STAFF REPORT

SUBJECT:	PRS 21-0081	PLANNING AREA:	Brandon
REQUEST:	Minor Modification to Interstate-75 Planned Development (IPD-1) 90-0097	SECTOR:	Central
APPLICANT:	Dallas Evans		
Existing Zoning District:	Interstate-75 Planned Development (IPD-1) 90-0097	Future Land Use Category:	Community Mixed Use-12 (CMU-12)

PRS 21-0081

SLAMBALL TAMPA - GENERAL SITE PLAN BROADWAY CENTRE - LOT 1 BLOCK 1 FOLIO NO. 65683.5702

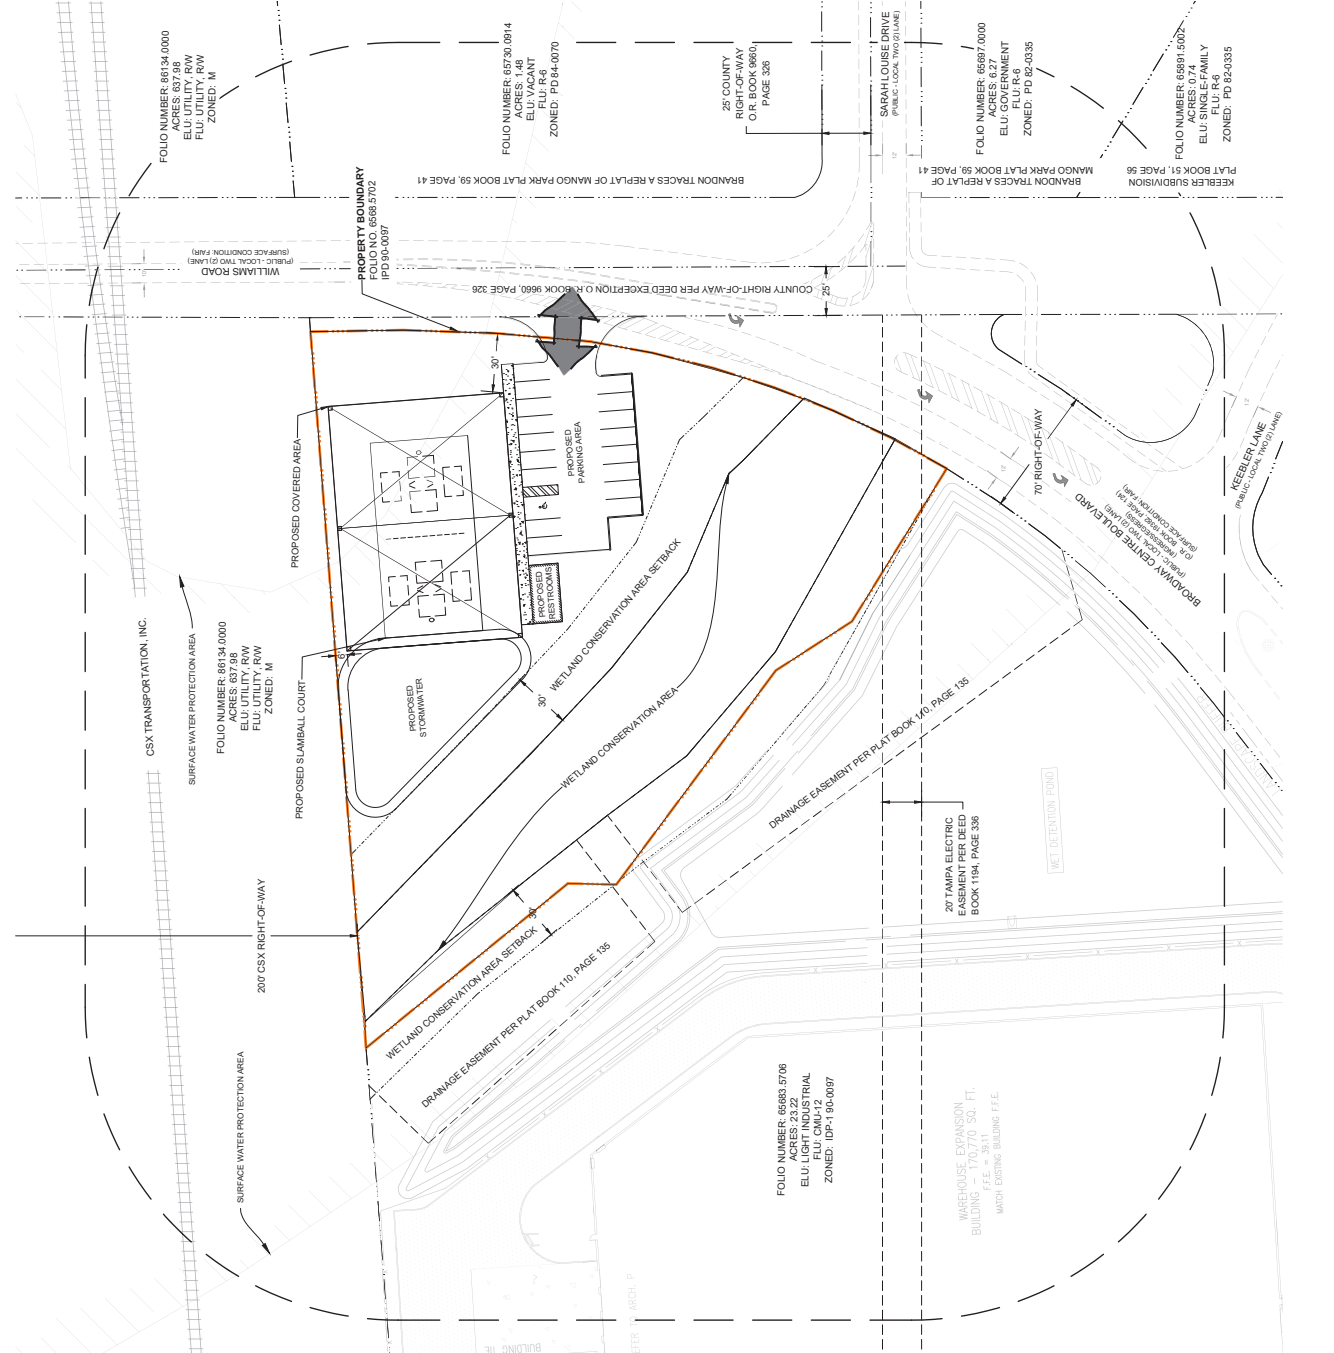
- The subject property contains wetland/OSW areas, which have not been delineated. Knowledge of the actual extent of the wetland and OSW are necessary in order to verify the avoidance of wetland impacts pursuant to Chapter 1-11. Prior to the issuance of any building or land alteration permits or other development, the wetlands/OSWs must be field delineated in their entirety by EPC staff or Southwest Florida Water Management District staff (SWFWMD) and the wetland line surveyed. Once delineated, surveys must be submitted for review and formal approval by EPC staff.

- Chapter 1-11, prohibits wetland impacts unless they are necessary for reasonable use of the property. Staff of the EPC recommends that this requirement be taken into account during the earliest stages of site design so that wetland impacts are avoided or minimized to the greatest extent possible. The size, location, and configuration of the wetlands may result in requirements to reduce or reconfigure the improvements depicted on the plan.

- The Hillsborough County Land Development Code (LDC) defines wetlands and other surface waters as Environmentally Sensitive Areas. Pursuant to the LDC, wetlands and other surface waters are further defined as Conservation Areas or Preservation Areas and these areas must be designated as such on all development plans and plats. A minimum setback must be maintained around the Conservation/Preservation Area and the setback line must also be shown on all future plan submittals.

ACCESS EXHIBIT
SHEET NUMBER: 1

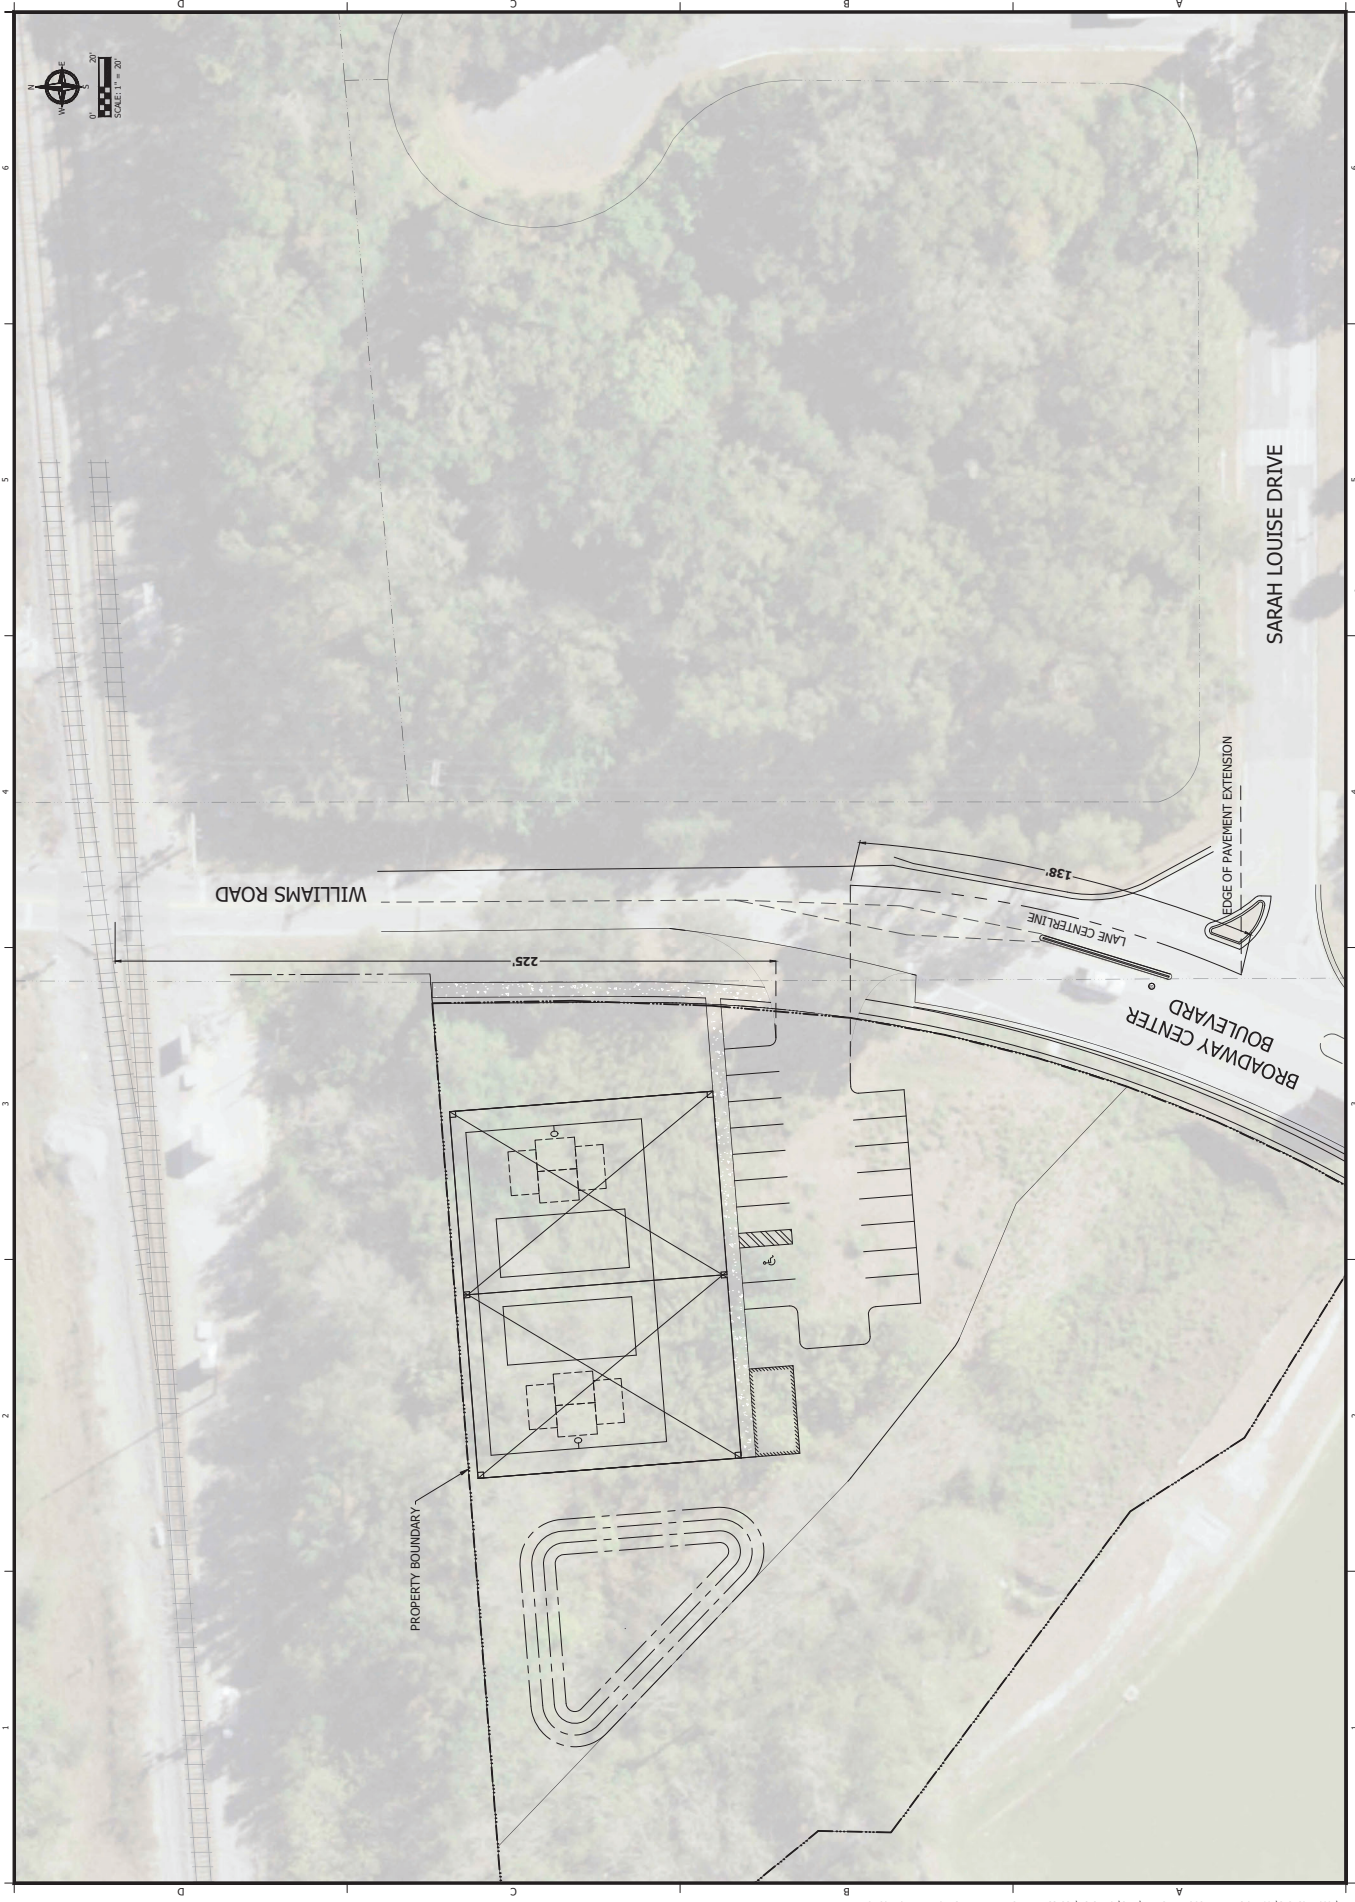
5,000 vehicles per day, which would classify the roadway as a collector per County standards. Section 6.04.07 specifies a 245 ft connection spacing for roadways with a posted speed of less than or equal to 45 MPH (Williams Road is posted as 35 MPH). The proposed site design would provide a connection spacing of 138 ft from Sarah Louise Drive; we are requesting a reduction in access connection spacing of 107 ft.

The subject property's frontage along Williams Road spans from the CSX railroad right of way to the north to Sarah Louise Drive to the south. The proposed right-in, right-out driveway access would be located approximately halfway between the edge of the railroad right of way and Sarah Louise Drive. The railroad tracks themselves are further north into the CSX right of way, which provides additional distance from the actual at grade railroad crossing and the project driveway. This additional distance will provide time for drivers to refocus on the roadway after crossing the railroad tracks.

Per discussion with James Ratliff, we have also reviewed intersection sight distance from the proposed driveway. There are several existing trees between the proposed driveway and the CSX railroad which fall within the sight triangle and would limit visibility of oncoming vehicles. We propose that these trees be cleared with site construction to provide adequate site distance.

We respectfully request approval of a 6.04.02B administrative variance for the access. Please feel free to call me if you have any questions regarding this application.
